Note to editor/reviewers. Plain text represents the original comment, and bold text represents the response.

Reviewer 1:

The paper presents a valuable exploration of the sources of error and potential improvements of common predictive methods for debris flow parameters. I have a few suggestions below:

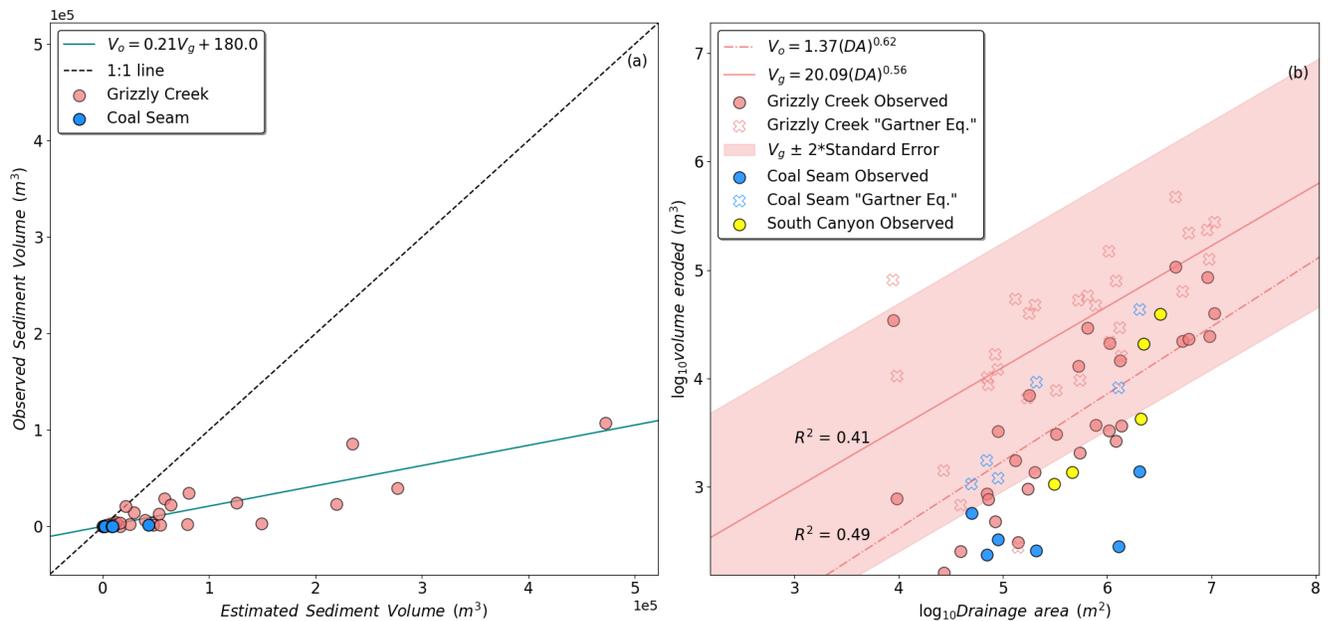
Figure 9 - Traditionally, shouldn't the observed (known) quantify be on the x-axis and the predicted (unknown) be on the y?

11. Figure 9. The value of (b) is not clear to me, other than as a means to add the south canyon data. Visually the power law lines do not seem to fit the data well.

Fig 9A: The 1e5 scientific notation next to axis labels is too small. Consider blowing up this text or adding it alongside the units (e.g., $1e5 \text{ m}^3$).

Fig 9B: I think the power law fits could be better coordinated with their respective point grouping colors – why have a V_p blue power law fit that does not match corresponding points with open red x's and V_o black dashed fit that does not match red circles. Also, these power law fits do not visually seem to fit their respective datasets very well. Additionally, it would be good to provide an estimate of goodness of fit metric (R^2) as well as p-values (or confidence intervals) for regression parameters (prefactor and exponent) to provide some degree of confidence of these fits.

This is a good point. Typically, when fitting a model, you would definitely do it that way. In this case the predicted quantity of sediment volume is also known, so we are not looking at how an unknown varies as a function of the known. The reason we plotted the data in this way, is so that the coefficient of the line is what you multiply the predicted value by to get a corrected estimate. For example, taking the volume from the Gartner equation and multiplying by 0.21, as shown in our equation in the plot, is a little bit easier than if we plotted the opposite way because you would have to swap the sides of the equation to get a correction factor. It's not really hard, but we wanted to make the process as easy as possible.

I think part of this confusion is that we use the term "predicted", and create a variable called Vp. We have now changed the variable to Vg, representing Volume from the Gartner equation. In addition, we have changed to language throughout to say "estimated" volume rather than "predicted" volume. We think this will help clarify this issue for readers.

One addition that I have now made, is that I added a band of plus or minus 2*standard error, to Figure 9 for reference (see below) because 95% of the data should fit within this. Also, this is close to +/- one order of magnitude and the Emergency Assessment model observations fit within plus or minus one order of magnitude. So we now give readers a sense of the range that they should consider when looking at the volume estimates from Gartner et al., 2014.

Good question regarding the value of (b). The main thing to observe is that the volume increases monotonically with drainage area. Therefore, we could apply a simple correction factor to lower the estimated volumes and that should work across drainage basins. I point this out in this text:

As far as the power-law fit, we now show an R^2 value and $2 \times$ standard error (which should capture 95% of the points around the trendline) so readers can interpret goodness-of-fit metrics. Also note that most debris-flow volume data are fairly noisy. Take a look at Figure 2 in Gartner et al., 2014 for reference.

I increased the fontsize for clarity. See new version of figure below in response to next question.

Some very good suggestions here. First, regarding colors, we agree, this can be improved. I think we have now simplified the colors to make it more clear. Here our revised logic for the new color choices. We are only fitting a line to the volumes predicted and observed at Grizzly Creek. We are then superimposing the Coal Seam and South Canyon data points to show how they compare. Therefore, because we use the red/pink color for Grizzly Creek data, we've made the power-law fit lines red/pink as well. We just use different line styles to differentiate them. We have also changed the color of the South Canyon Fire data to yellow from black, so that it isn't confused as having a relationship with the lines in Figure 9a.

As for powerlaw fit. We agree that the fit isn't great, and that the data don't conform to the assumptions of a normal distribution. Therefore, reporting a p-value doesn't really make sense. However, we do report the R² values on the plot now (see below) and show +/- 2 standard error, which should capture 95% of the data.
